WASHOE COUNTY
COMMUNITY SERVICES DEPARTMENT
Planning and Building

Subject: Addendum to staff report for Special Use Permit Case No. WSUP18-0008 (Arconic)

INSPECTION REPORT

FACILITY TITLE: ARCONIC

Figure 13 - Original design plans of Shop Pond walls

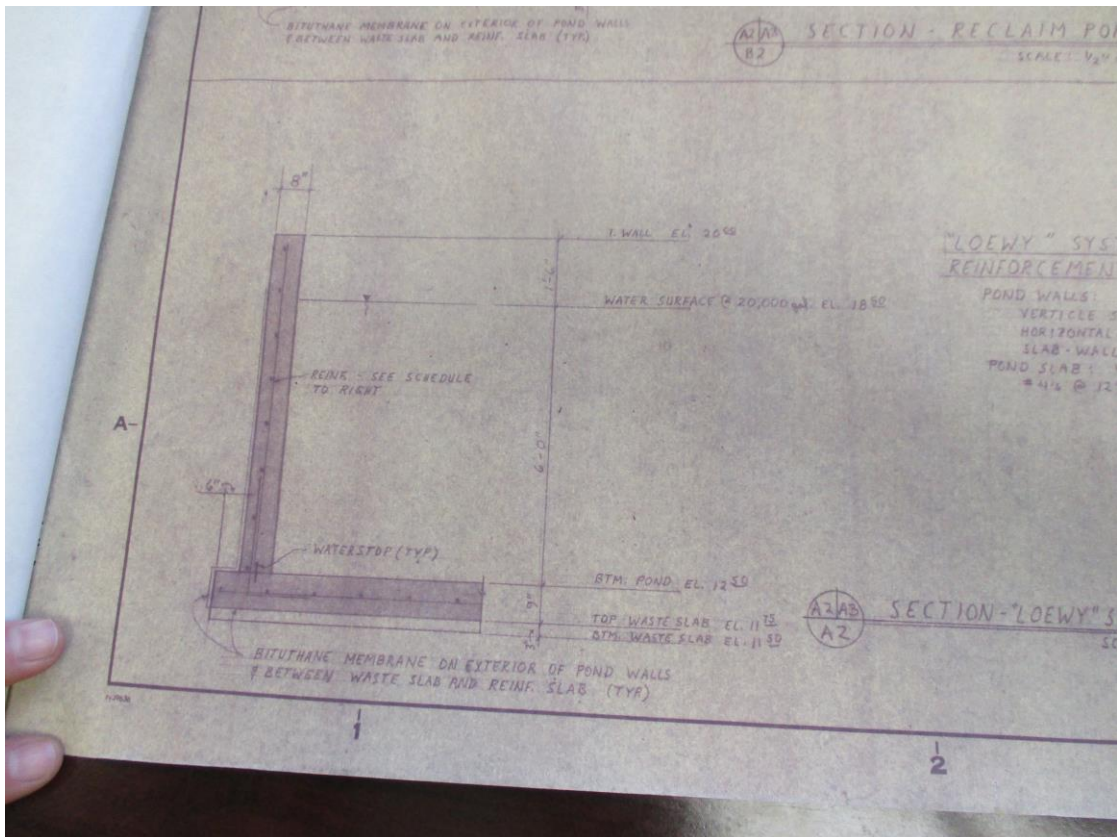
Eventually, the water will make it into the Shop Pond (Figure 12) where it can then be recycled for cooling water. NDEP didn't measure the freeboard in the Shop Pond, but it appeared to be approximately 2 feet. Figure 13 shows the original design plans of the concrete pond. The concrete pond was not constructed with leak detection, but was constructed with a bituthane membrane for additional waterproofing of the concrete structure. The pond was constructed in approximately 1978. It is unknown if an evaluation of the pond has ever been conducted but it is known that a full pond evaluation has not been completed in recent years.

NDEP found that Arconic is meeting the terms of its current Discharge Permit. It was noted that that Shop Pond is approximately 40 years old and should be fully evaluated to assess the integrity of the structure.

No.	Recommendation
1	Complete a full evaluation of the concrete shop pond

- p. Prior to the issuance of any building or grading permit, per the Nevada Division of Environmental Protection (NDEP) Compliance Evaluation Inspection memo, a full evaluation of the concrete shop pond must be completed and submitted to Washoe County Engineering, Washoe County Planning, and NDEP.
- q. If any new outfalls are established, there shall be appropriate BMP's utilized.
